# RECEIVER MIXER IMPROVEMENT FOR YOUR DRAKE TR-4 TRANSCEIVER.

Original TR-4 RX mixer circuit

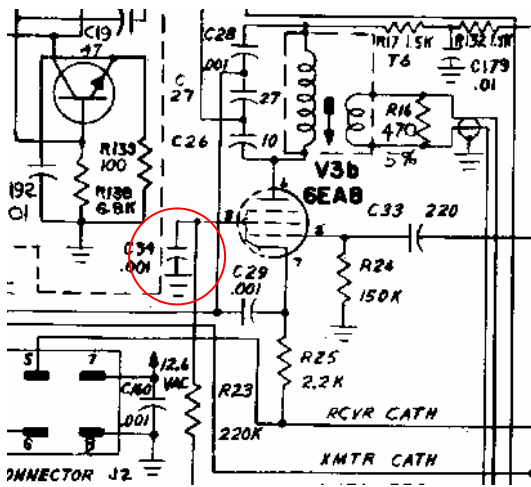
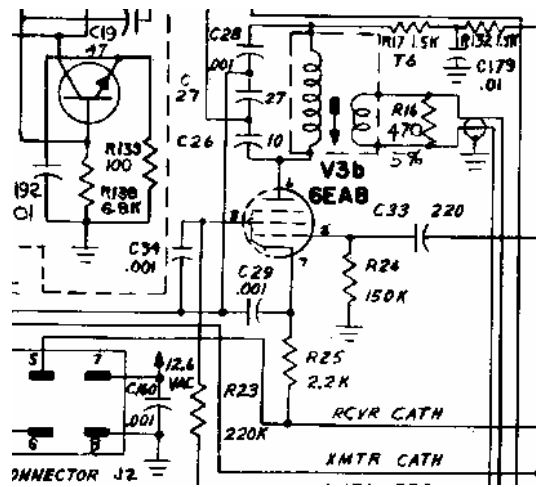
DRAKE TR-4 transceivers employ a pentode in the first (and only) receiver mixer. This device somehow defines the ability of the receiver to detect faint signals near stronger ones.

In pentodes, cathode current is determined by the voltage between first grid and cathode and the voltage between screen grid and cathode. If you look at the schematic diagram, and put a “virtual” ground on cathode, you see that input signal is applied to the first grid and local oscillator is applied to both first and screen grids. Conceptually it is like using a diode mixer and applying the input signal to first port and local oscillator to both first and second port! This is certainly a method to degrade the performances.

The mixer design can be corrected at no cost.

The same mod apply to V1b, the pre-mixer pentode. This is useful for the 40 m band. In fact the xtal for 40 m is 21.5 Mhz. With VFO at 5.4 MHz we have  $21.5 - 5.4 - 9 = 7.1$  Mhz, but we also have  $5.4 * 3 - 9 = 7.2$  MHz, which is unwanted. Reducing the “chaos” produced by the two VFO inputs to V1b, improves the situation.
